**Federal  
Highway  
Administration**

September 11, 2007

In Reply Refer To: HSSD/B-162

In his letter of May 7, 2007, Mr. Dallas James of Armorflex Ltd requested formal Federal Highway Administration (FHWA) acceptance of a new steel strong post (called the Nucor Steel Post) for use in a new 31" (787 mm) high Nucor Strong Post W-beam guardrail system with no blockouts in both roadside and median applications. He also requested formal FHWA acceptance of the Nucor Steel Posts as a substitute for other approved posts in the standard 27" (686 mm) high non-proprietary strong post W-beam guardrail systems with the use of an original plastic blockout. This request was limited to roadside applications only. To support his request, Mr. James also provided a copy of a Holmes Solutions Limited test report dated March 2007, entitled "31 Inch Nucor Strong Post W-Beam Guardrail without Blockouts" and a copy of a Holmes Solutions Limited test report dated March 2007, entitled "27 Inch Nucor Strong Post W-Beam Guardrail with Plastic Blockouts." Mr. James also provided copies of the drawings, test videos, photos, raw data and analysis files and a copy of the correspondence with Mr. Nick Artimovic

RIB-BAK W-BEAM LINE POST

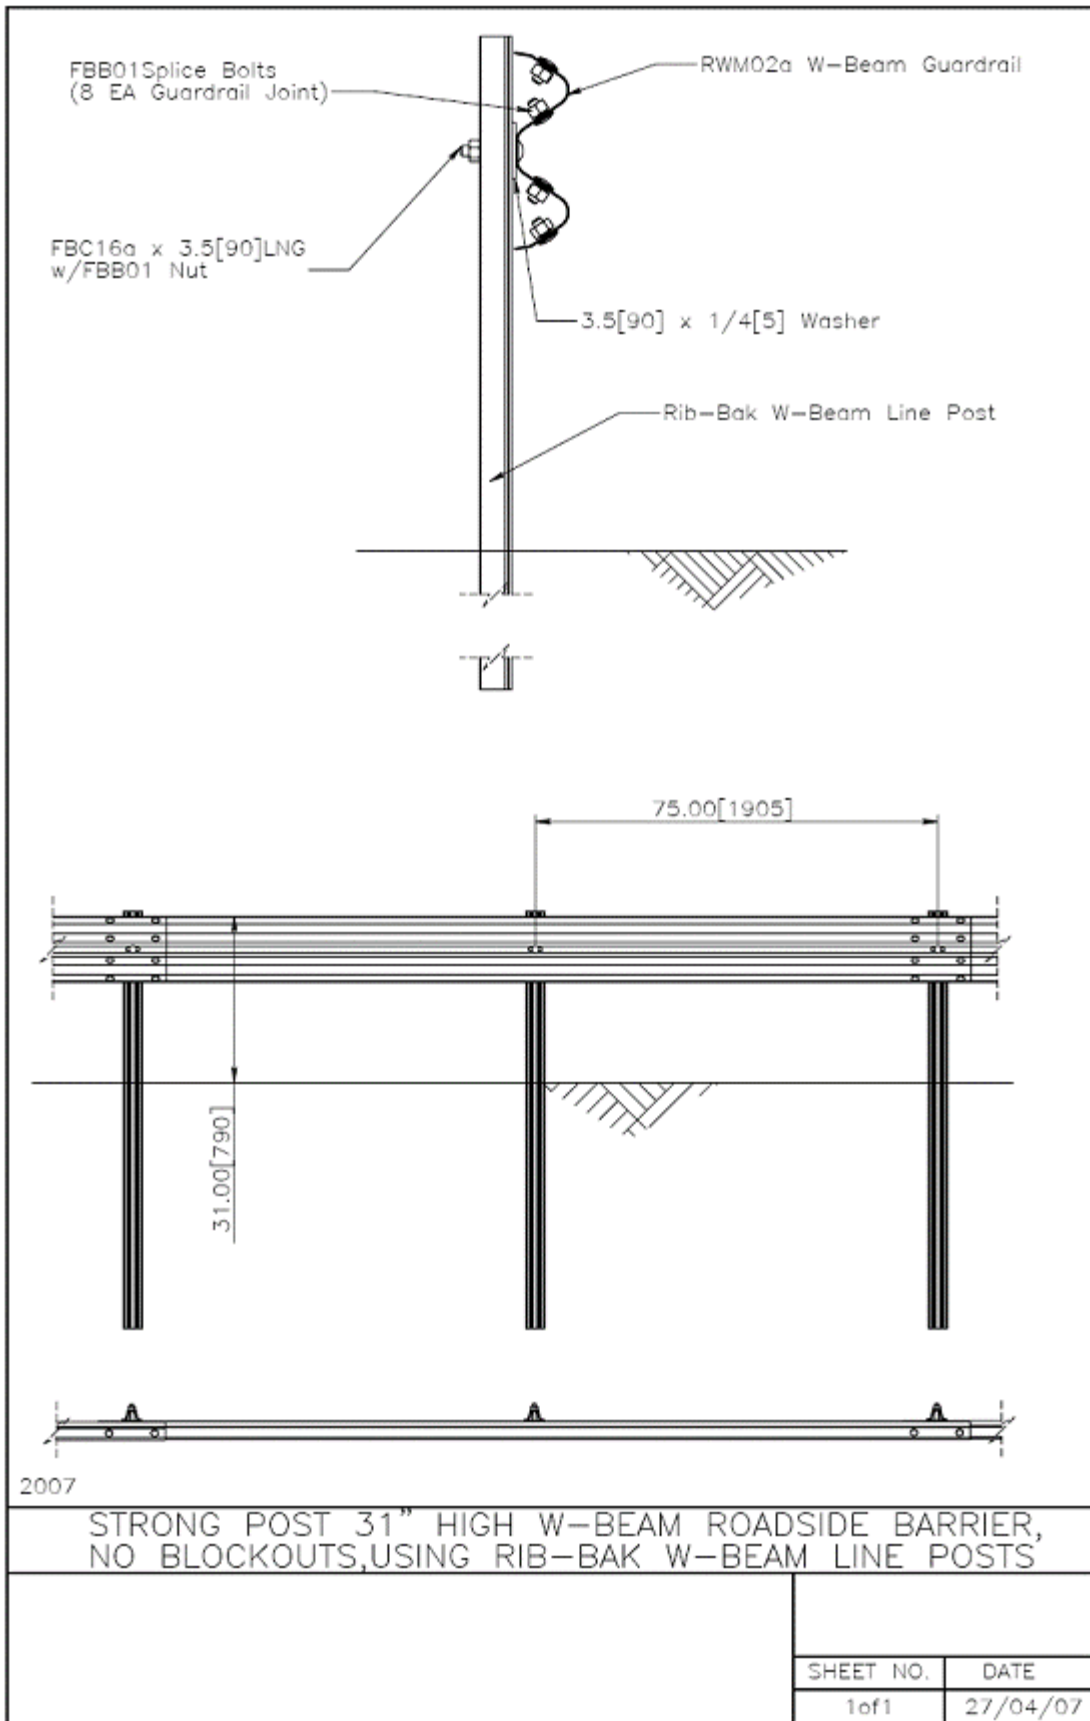
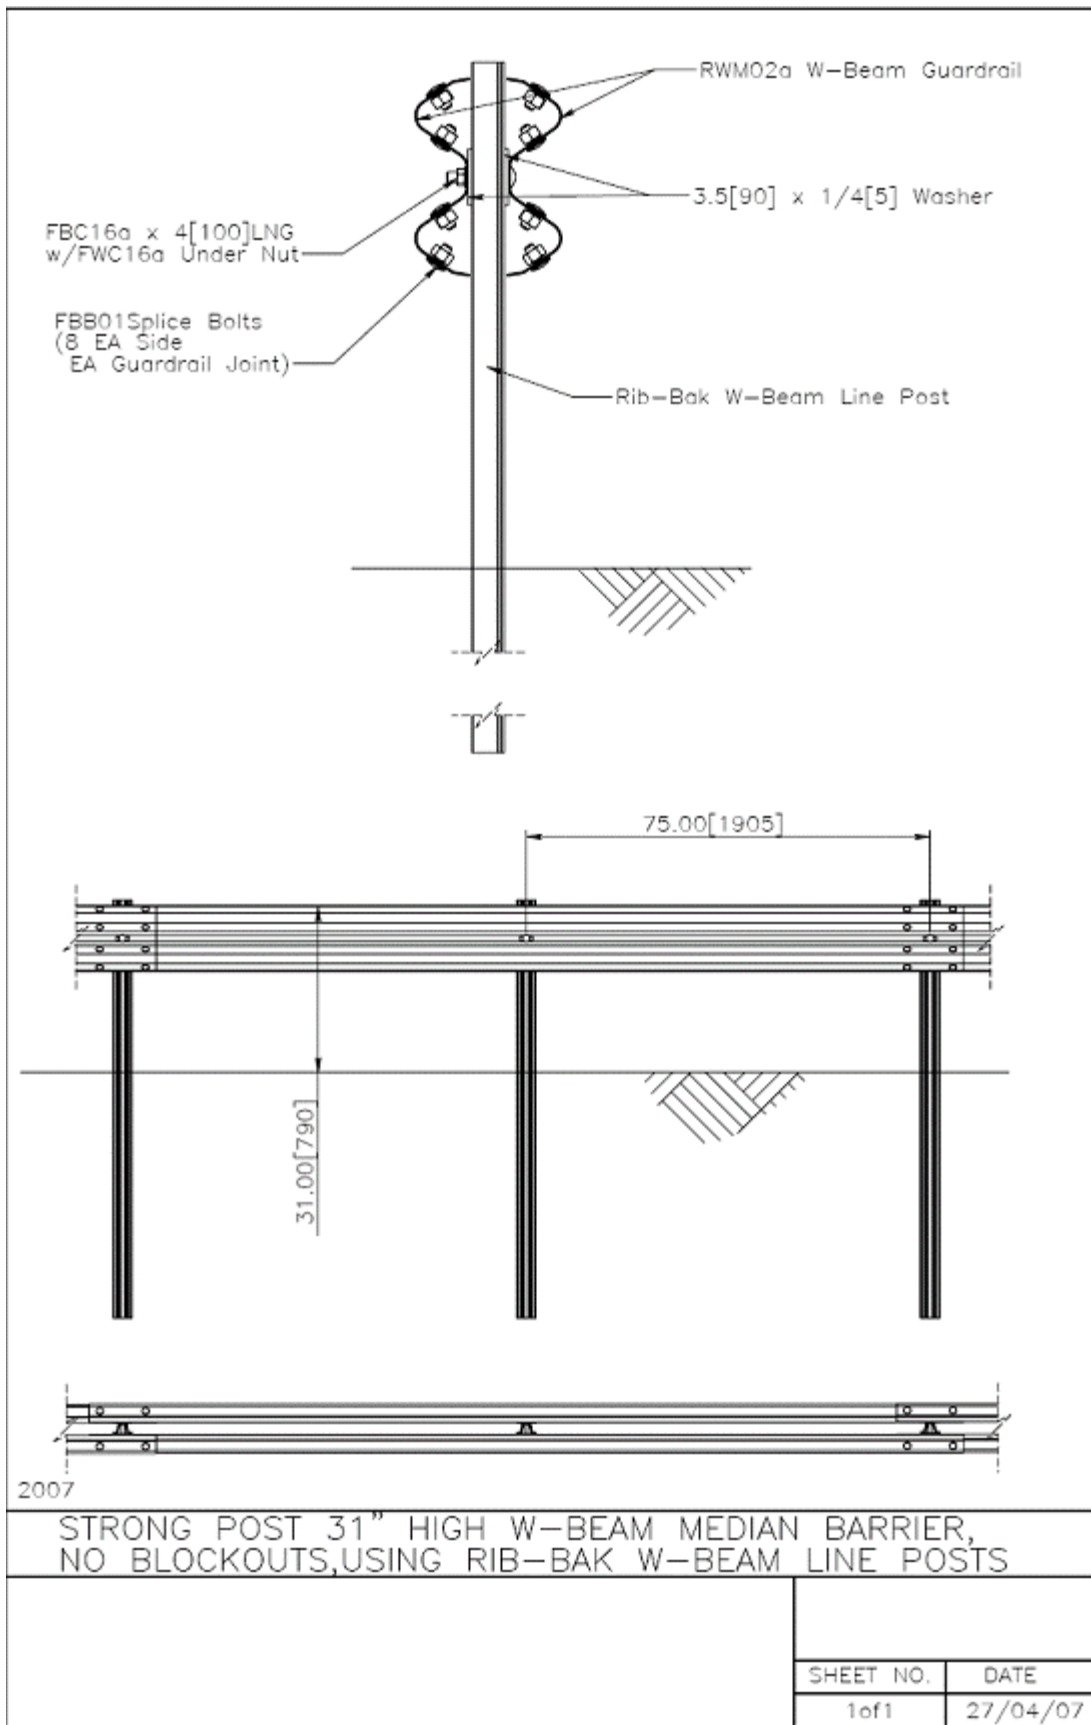
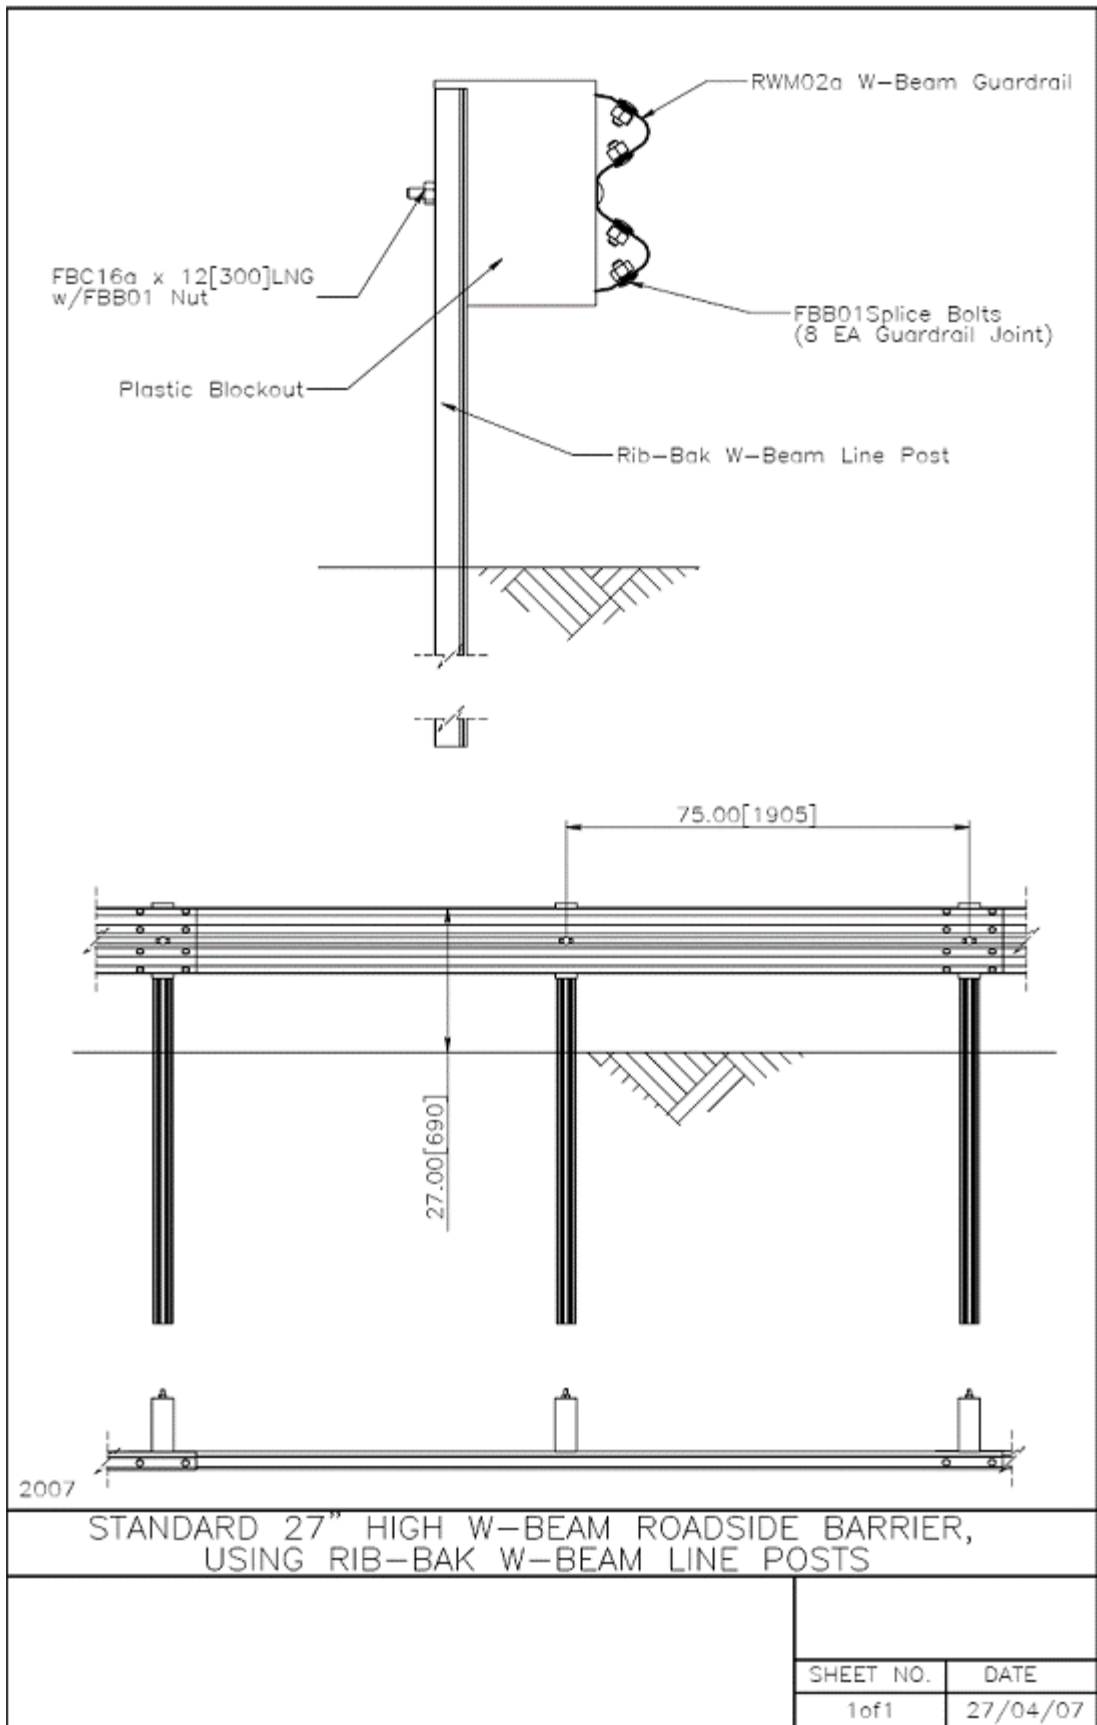
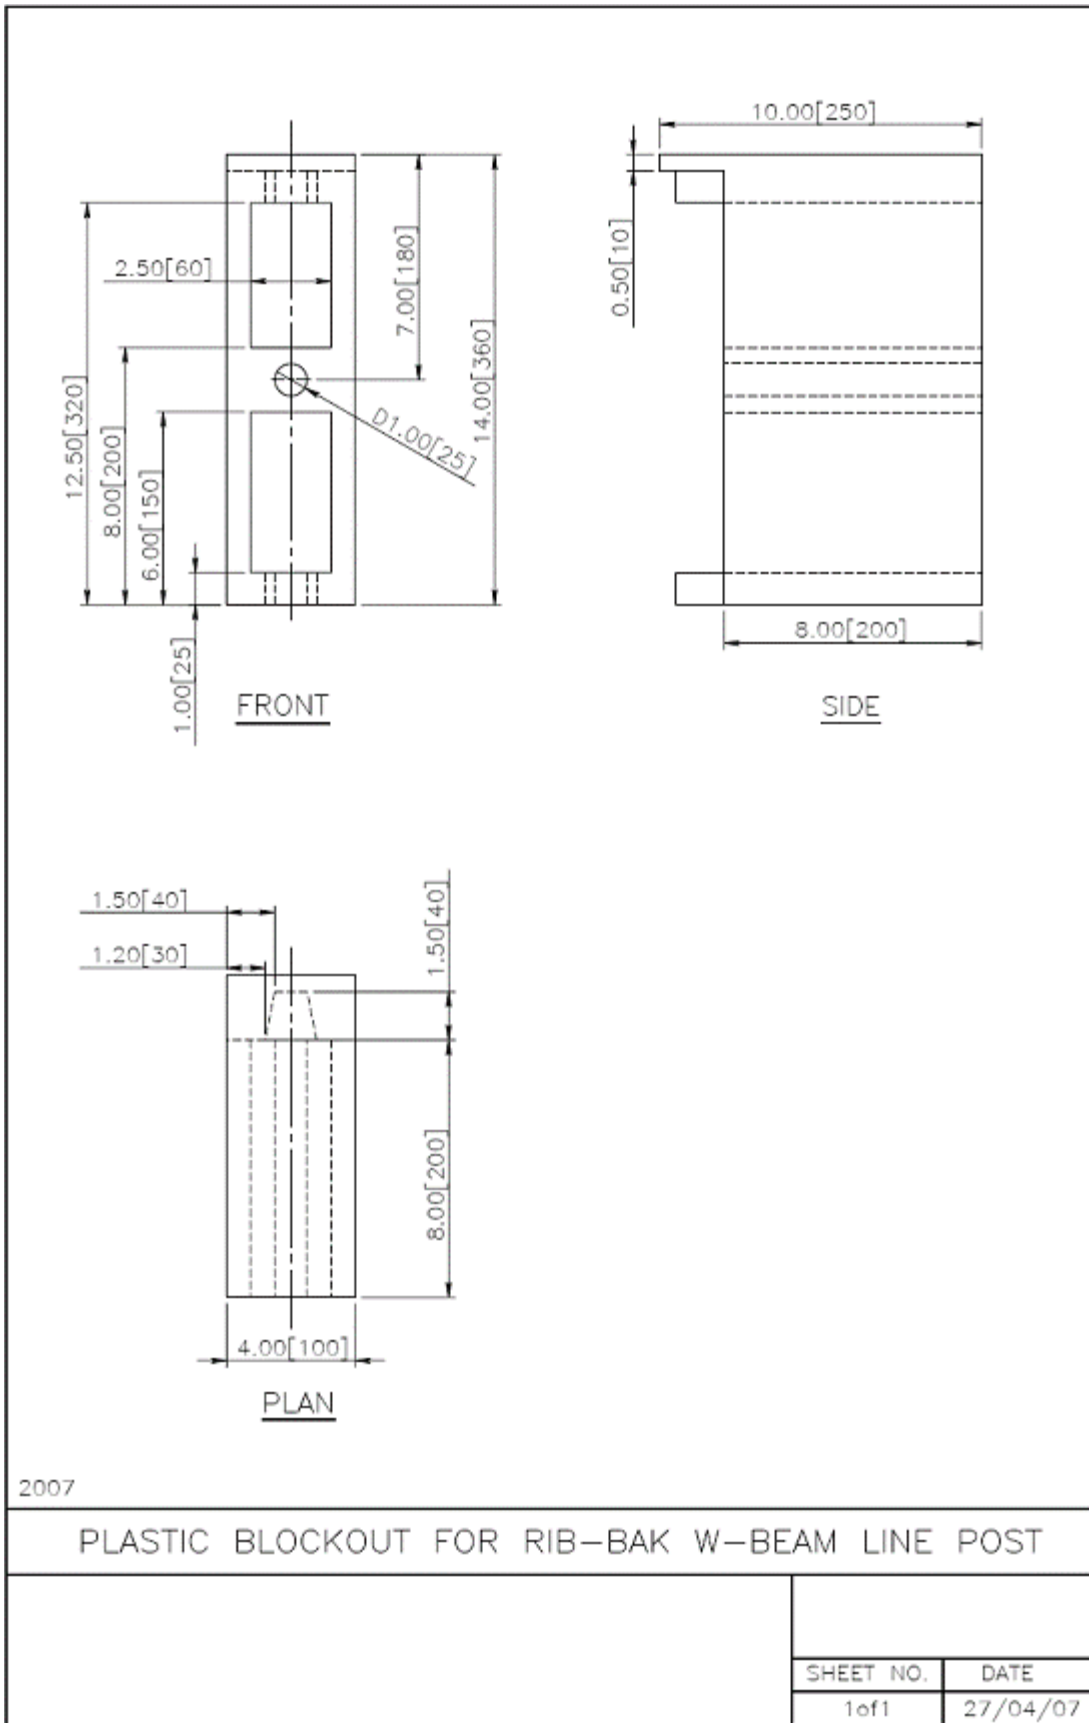
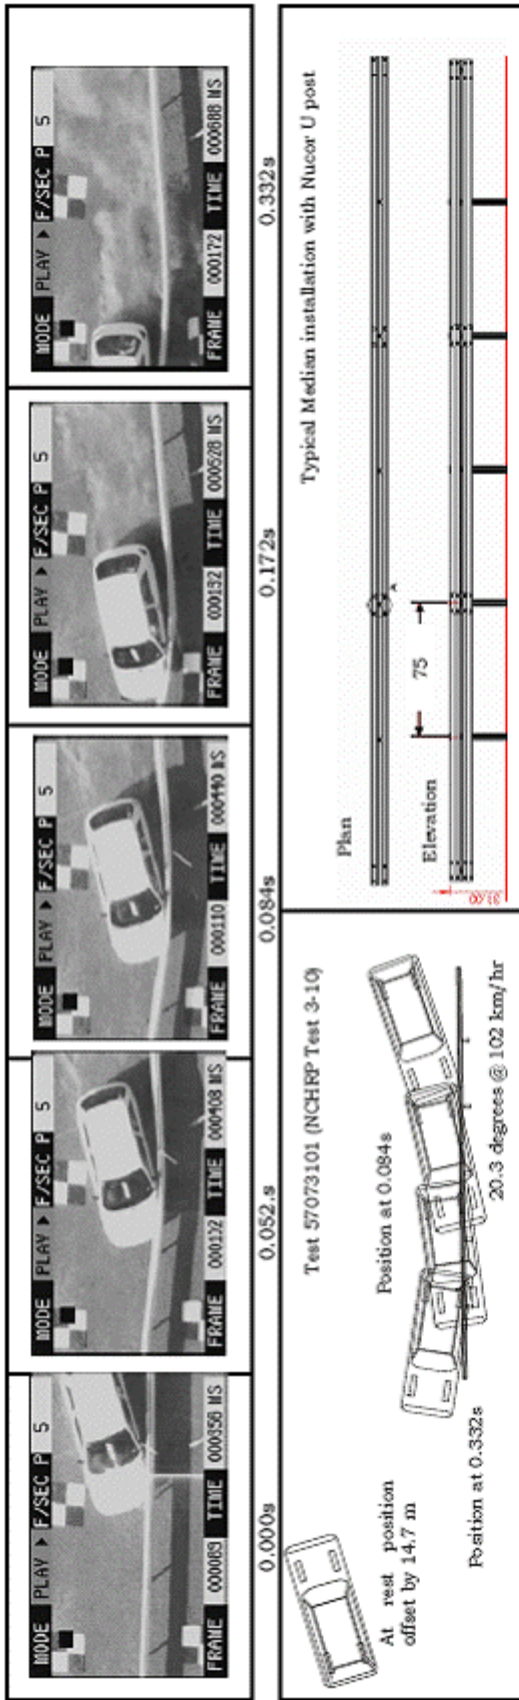
Nucor Strong Posts are hot rolled high tensile steel fabricated into a U cross section of approximately 2" (50.8 mm) deep and 3-1/2" (88.9 mm) wide. The total weight of the posts is 5 pounds (2.27 kg) per foot. A slot, 3/4" (19.1 mm) wide is located 1" (25.4 mm) down from the top of the posts in the middle of the cross section. The slot has a total length of 7" (178 mm). All posts are 78" (1981 mm) long and hot dip galvanized. Design details for the Nucor Strong Posts are shown in Enclosure 1.

When Nucor posts are used in a new 31" (787 mm) high Nucor Strong Post W-beam guardrail system, the blockouts are not used and round spacer washers are installed between the guardrail and the legs of the U posts. Round spacer washers are manufactured from 1/4" (6.35 mm) mild steel plate with an outside diameter of 3-1/2" (89 mm) and a centrally located hole of 1" (25.4 mm) in diameter. The washers have a hot dip galvanized finish. The washer is captured in place by the 5/8" x 3-1/2" (15.9 mm x 88.9 mm) post bolt and splice nut and is used to provide a backing surface for the guardrail to limit the possibility of the head of the post bolts from pulling through the guardrail. The use of the 1/4" (6.35 mm) washer is a change to the original design implemented after

Test 3-10 was completed. Design details for the Nucor Strong Post W-beam guardrail system in both roadside and median applications are shown in Enclosure 1.

When Nucor posts are used with 27" (686 mm) high non-proprietary W-beam guardrail systems, they are used with the original plastic blockouts, 14" x 3-5/8" (355.6mm x 92.1 mm) which are used to space the guardrail 8" (203 mm) from the face of the U posts. The plastic blockouts are manufactured from a 50 percent blend of new and recycled HDPE (high density polyethylene). Design details for the Nucor Strong Posts as used with 27" (686 mm) high W-beam guardrail systems with blockouts are shown in Enclosure 1.

**General Information**  
 Test Agency ..... Holmes Solutions, New Zealand  
 Test Designation ..... NCHRP 350 Test 3-10  
 Test No. .... 57073101  
 Date ..... 5 March, 2007

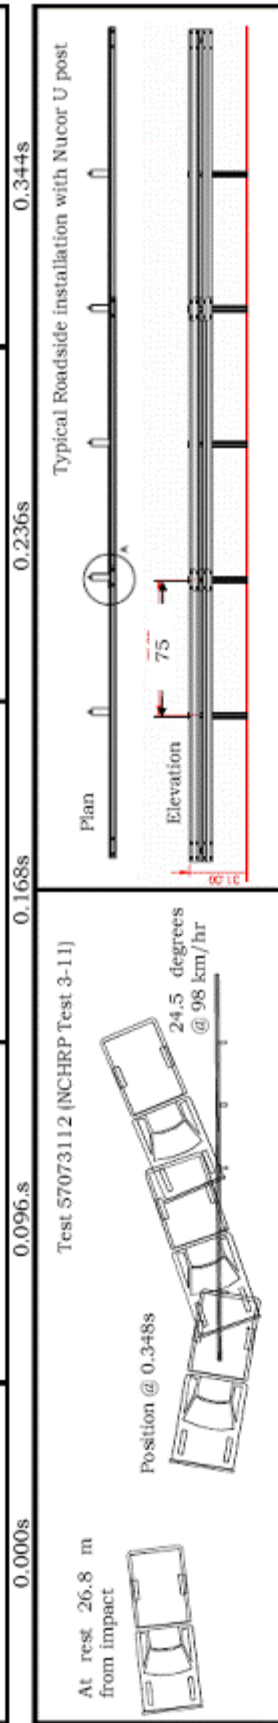
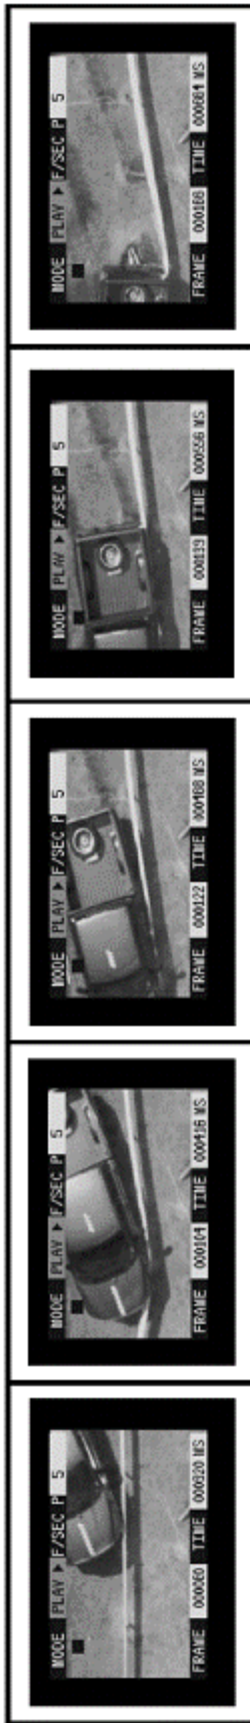
According to the information you provided the test article performed successfully in the above tests. The system redirected impacting vehicles which did not penetrate, underride, or override the installations and remained upright during and after the collision period. There was only minor deformation of the occupant compartment. Occupant risk factors were within the limits specified in the NCHRP 350. Summaries of tests results are presented in Enclosure 2.

In the conducted tests no detached elements, fragments, or other debris showed potential for penetrating the occupant compartment, nor to present an undue hazard to other traffic. However, in test 3-10 one post was broken off at ground level with a large segment of the post coming to rest 6 m behind the barrier approximately 17 m downstream from the point of impact. Test videos show that the broken off part of the post was sliding at ground level before coming to rest and therefore the hazard to other traffic in median application on a level surrounding surface would be minimal. However, the described tendency of the posts to break off should be recognized and should be taken into account when selecting locations for installations. Also, this tendency may be more pronounced when the system is used in the frozen ground or when the surface is paved.
